**EPA Comment**  
**G-1 Fluid Injection**

**EPA Comment****G-5 (1 and 2) PA Computer codes - SANTOS, NUMBERS and DRSPALL**

**EPA Comment**  
**G-7 Transmissivity Fields**

**Figure TFIELD-17. Example of Categorical Simulation over a Model Domain using Two Categories**

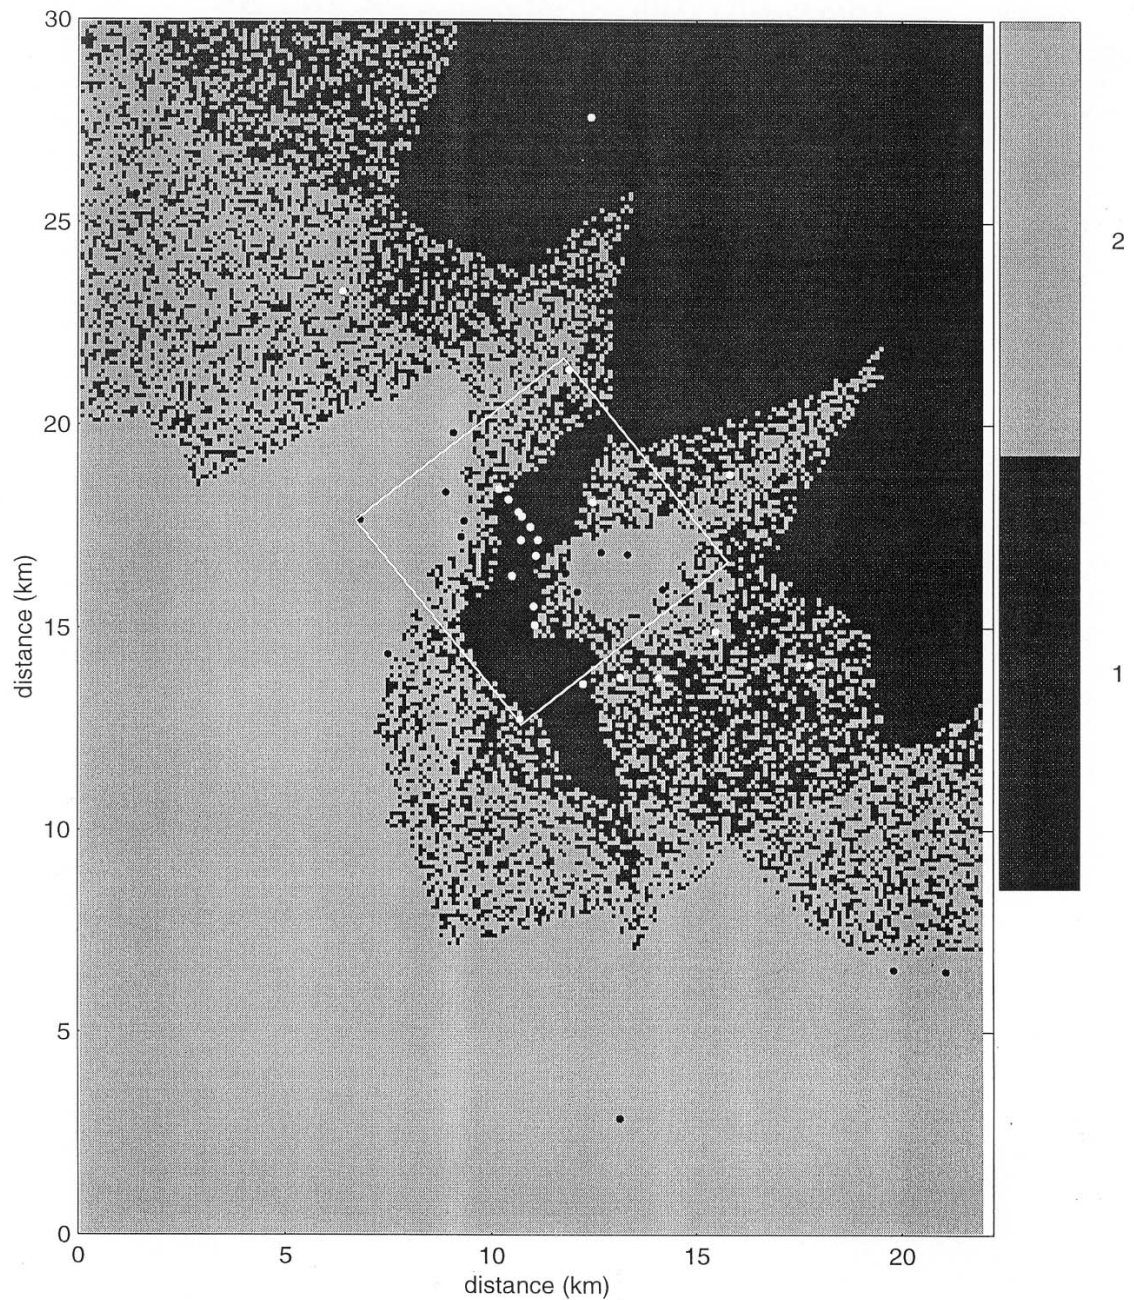
*Our preliminary review has raised questions about the technical justification for modeling a low transmissivity field for the Culebra in the southeastern part of the WIPP site. This approach contrasts greatly with the modeling approach used in the original Compliance Certification Application and could directly affect estimated ground water travel times. For these reasons, we anticipate that the use of such a model must be supported either by further analysis and justification of its effects (or lack thereof) on the performance assessment results, or by the presence of empirical data demonstrating the existence of such a low transmissivity field (i.e., monitoring data from a new well drilled in the vicinity).*

While the conceptual model for the Culebra as a confined aquifer did not change from the CCA to the CRA-2004, the way in which the initial (pre-calibration) transmissivity (T) distribution within the Culebra was defined did change. The CCA relied almost entirely on geostatistical methods to define the distribution of T within the Culebra. The Culebra was divided into two zones (what we might call “high T” and “low T”) using Indicator Categorical Simulation and the known spatial distribution of wells showing high T and low T (DOE, 1996, Appendix TFIELD, Section TFIELD.3.1). Within the model domain, each cell was stochastically assigned to either the high-T or low-T zone in a sequential but spatially random manner. This assignment was made on the basis of the probability defined by the category(ies) of the three nearest already-categorized cells combined with the overall probability of high or low T defined by the relative proportions of high-T and low-T wells in the WIPP monitoring well network. This approach resulted in the “speckled” distribution of high (category 2) and low (category 1) T shown in CCA Figure TFIELD-17. T values were then assigned to each model cell in the two zones based on variograms of T values measured in each of those zones. Because the CCA T field calibration process started with approximately equal mixtures of high- and low-T categories south of the WIPP site boundary, it had the capability of creating throughgoing high-T features relatively easily. Such a high-T zone was suggested by LaVenue et al. (1988) as being necessary to achieve good calibration to steady-state heads in the southern WIPP region.

The development of the initial (pre-calibration) Culebra T distribution for the CRA-2004 is discussed in Sections TFIELD-3.0 and 4.0 of Attachment TFIELD to Appendix PA of DOE (2004). The Culebra was first divided into four T zones on the basis of geologic factors delineated on maps (Powers 2002a,b; 2003): dissolution of the upper Salado (“very high T”), no halite in the Rustler above the Culebra (“high T” OR “low T”), halite present above the Culebra but not immediately underneath (“low T”), and halite both immediately underneath and above the Culebra (“very low T”). Within these zones, T’s were assigned on the basis of a correlation defined by Holt and Yarbrough (2002) relating T to the depth to the Culebra. In the zone where no halite is present above the Culebra

T may be either high or low, a high-T indicator variogram was constructed, and the variogram parameters were used in conditional indicator simulations of high-T subzones. Transmissivities within the high- and low-T subzones were then assigned using the correlation discussed above.

The assignment of T in the region south of the eastern portion of the southern WIPP site boundary (south of H-11) was strongly affected by wells P-17 and H-17. The high-T indicator variogram had a correlation length of 1790 m. Because P-17 and H-17 both have low Culebra T and are only 1793 m apart, their combined influence on the region between them is much greater than the influence of the nearest high-T well (H-11), over 1600 m north. Although the probability of placing a high-T subzone between H-17 and P-17 was not zero during the modeling process, it was low enough that high T did not occur there in any of the 150 T fields that were later calibrated. Rather than go beyond the data and “hardwire” a high-T zone between H-17 and P-17 to ensure similarity with the CCA T fields, the geostatistical model based on the available data was honored, resulting in low T’s.
